TAILINGS MANAGEMENT PLAN EVALUATION

DAWN MINING COMPANY

FORD, WASHINGTON

U.S. Nuclear Regulatory Commission
NMSS

Figure 3.4. Typical Section of Pit (Source: Reference 2)

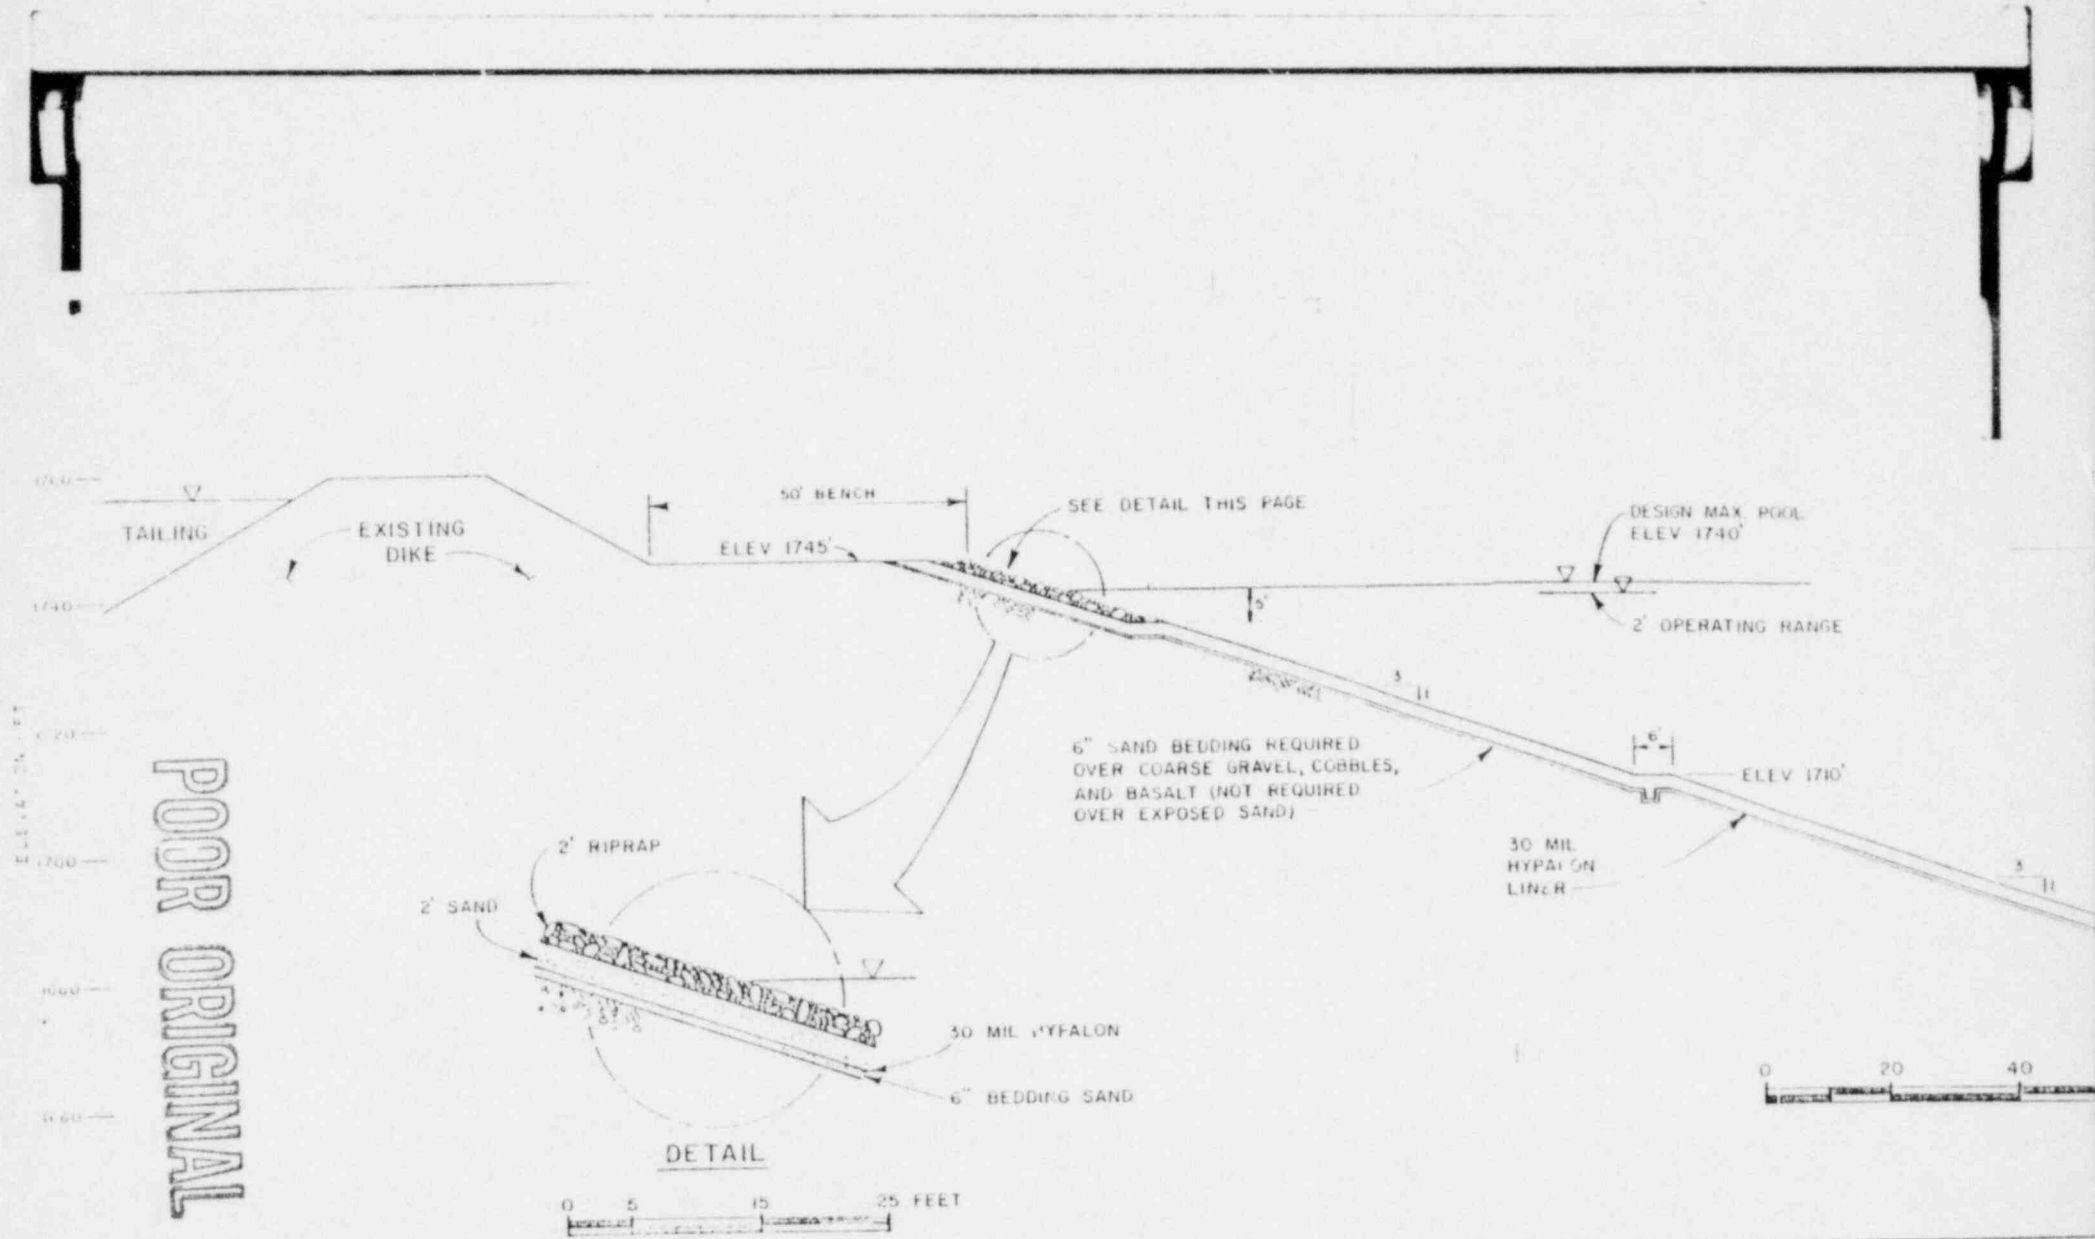
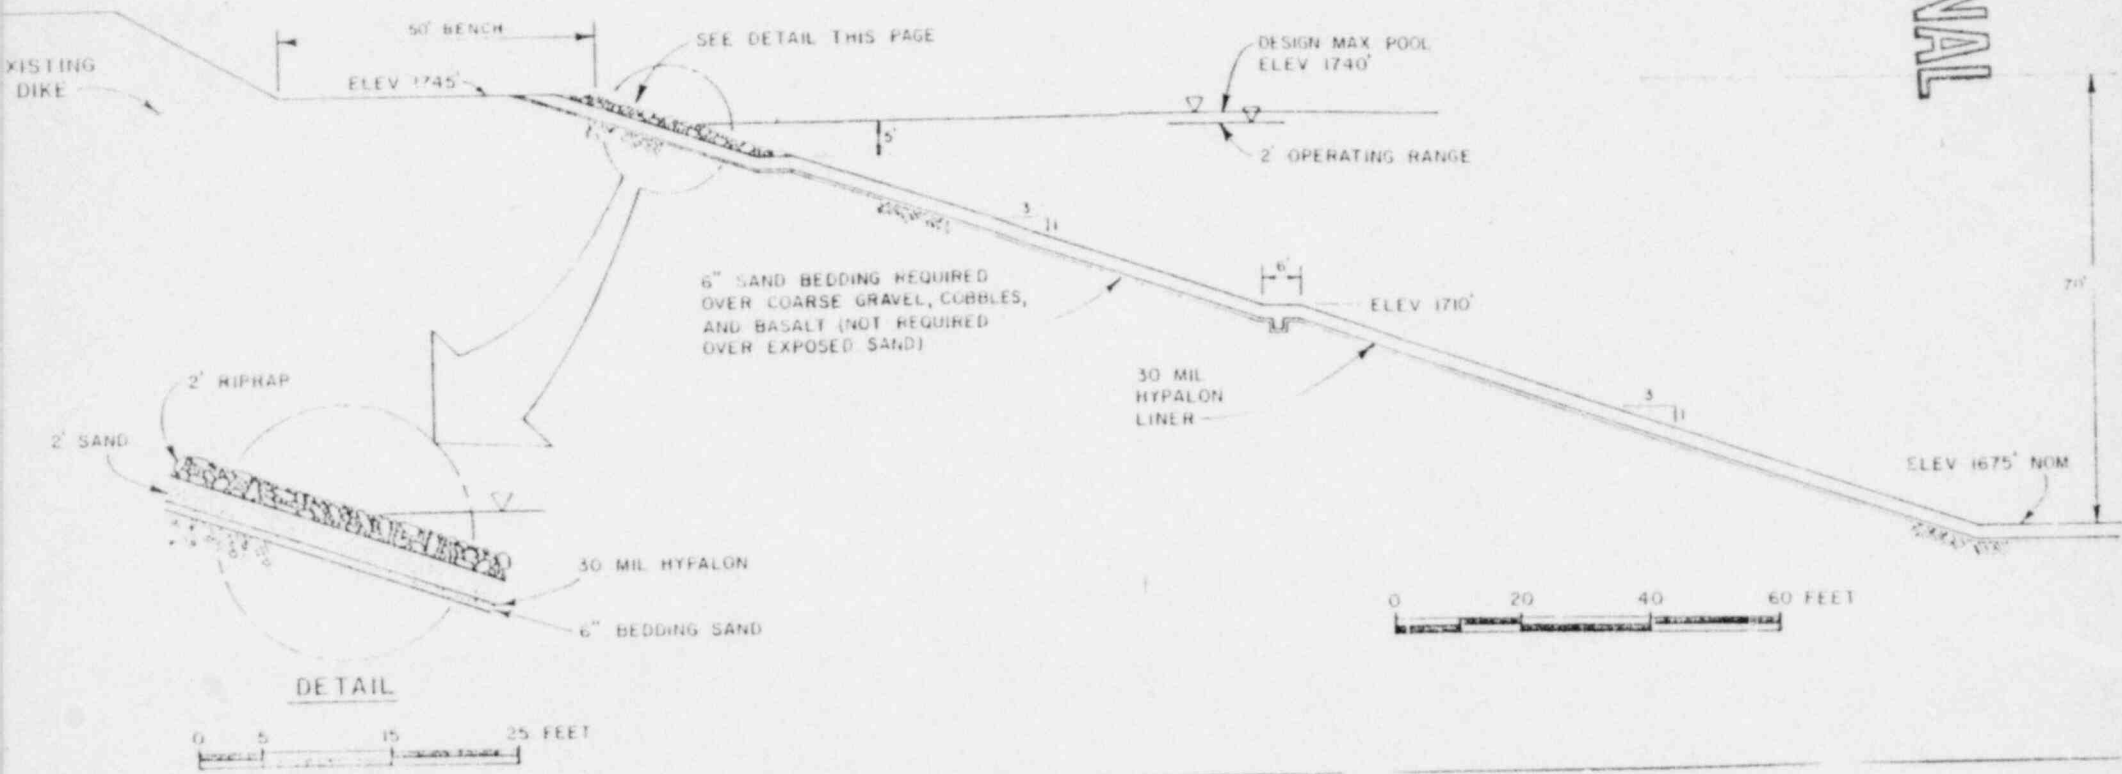
In Fig. 4 of the Golder Report (Ref. 2) and as shown in Fig. 3.4 of this report, riprap slope protection will be provided at the top edge of the pit. In response to the NRC question No. 4 (Ref. 4) it is stated that this riprap and Hypalon liner will be extended up onto the dikes. However, Fig. 3.4 does not indicate that the riprap on the liner will extend beyond the top of the pit. This point should be made clear in the specifications if, in fact, the liner and riprap is to extend onto the face of the dikes.

The upper ten feet of the embankment (i.e., elevation 1735 to 1745) will be riprapped to insure embankment protection from wave action as shown in Fig. 3.4. Consequently, wind and wave damage should be minimal. Because of the wave protection and the extreme conservatism with which the PMF was estimated, it is recommended that the proposed 5 feet of freeboard be considered adequate.

Specifications should be provided for the riprap material. The riprap should have a minimum average grain size (D_{50}) of 10 inches, it should be well graded, and it should meet filter criteria with the bedding sand.

Figure 3.6. Drainpipe Installation Details (Source: Reference 2)

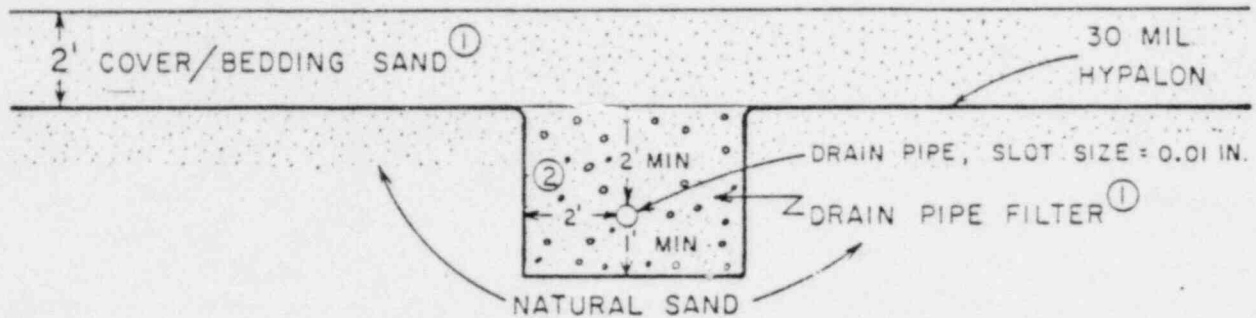
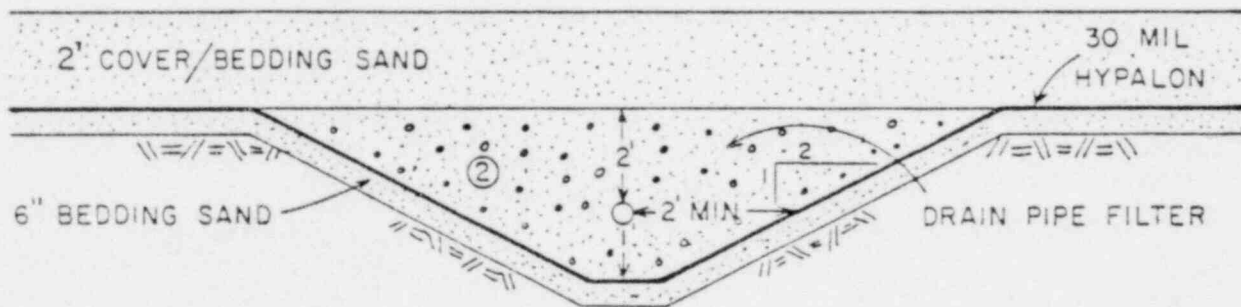
The underdrain system shown in Fig. 3.6 indicates various zones of sand and bedding material and tailings in contact with one another. Computations to check filter criteria are shown in Appendix C. The grain size distribution curves shown in Ref. 2 were stated to have been designed on the basis of Corps of Engineer criteria, whereas the criteria shown in Appendix C were taken from the Pit Slope Manual (Ref. 10). It is shown that for both the bedding and the drain pipe filter rules 2 and 4 have not been met. It is recommended, therefore, that the design gradation shown in the specifications for the bedding and filter material be revised so as to ensure conformance with rules 2 and 4.

The specified grain size distributions for the bedding sand and drain pipe filter should be adjusted so that filter criteria are met. (See Appendix C).

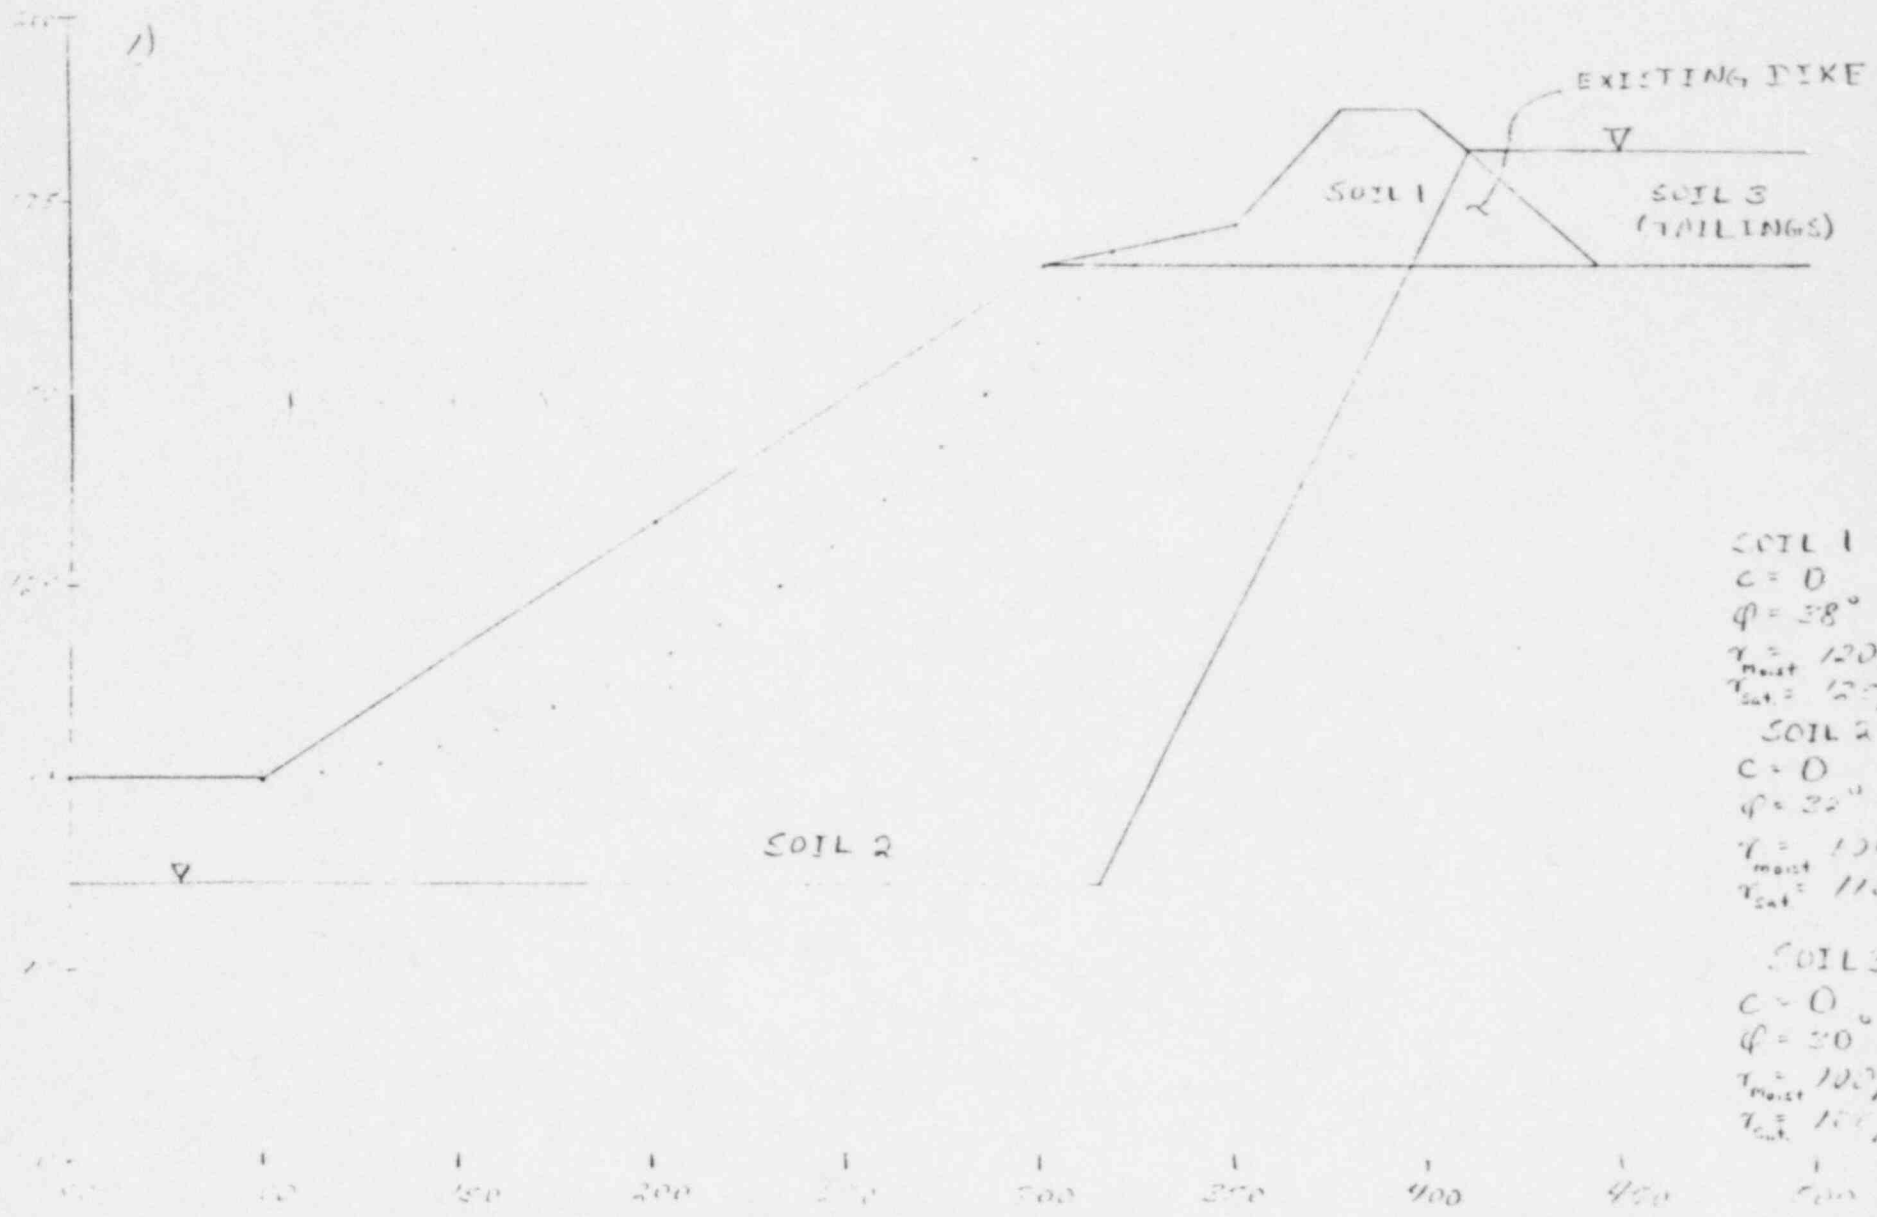
Slope stability analyses were conducted by the reviewers utilizing computer program STABL2. A total of ten potential failure surfaces were generated and the lowest factor of safety observed for those trial failure surfaces was 1.95. All other values were greater than 2. Results of these computations and the cross-section utilized is shown in Appendix A. The shear strength parameters used in these analyses were the same as those used by Golder Associates (Ref. 2).

The phreatic surface utilized in the stability analyses was the same as that used by Golder Associates. As discussed in the previous section describing the groundwater conditions at the site, this phreatic surface is considered to be realistic and even under fluctuations due to heavy rains it is not expected that the phreatic surface would rise above the bottom of the pit. The use of more realistic shear strength values could cause these values of factor of safety to be somewhat lower.

In general, the computed factors of safety for the stability of the pit walls is greater than a value of 1.5 required by USNRC Regulatory Guide 3.11. However, the shear strength values that were utilized in arriving at these factors of safety were unconservative and did not appear to have been corrected for overburden stress. Consequently, it is recommended that corrected values of blow count be utilized to arrive at more correct values of angle of internal friction. Alternatively, the results of shear strength testing such as direct shear tests could be used to indicate the reasonableness of the value that actually was utilized.

The assumed shear strength values are not consistent with correlations for corrected blow count values. Additional analyses should be conducted to indicate that adequate factors of safety will exist for shear strength values consistent with the lower corrected blow count values. Alternatively, laboratory or field shear strength testing data should be provided to indicate that the value of shear strength parameters are realistic.
